Development Facilitation Team (DFT) – Review Comments

Project No: PR-2024-010464 Date: 6/26/2024 Agenda Item: # 7 Zone Atlas Page: F-23

Application For: VA-2024-00165 – SIDEWALK WAIVER

Request: Waiver DHO – Reduce the driveway requirement of 20 feet by 32 inches

FIGURE 7.2.41 Street Element Dimensions Along Major Roads

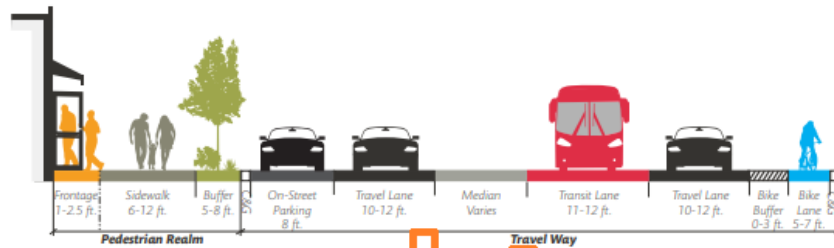
- 5-3(D)(1)(a) Perimeter sidewalks shall be provided in accordance with the DPM.
 - Be in compliance with Table 7.2.29 of the DPM; see exhibit below.
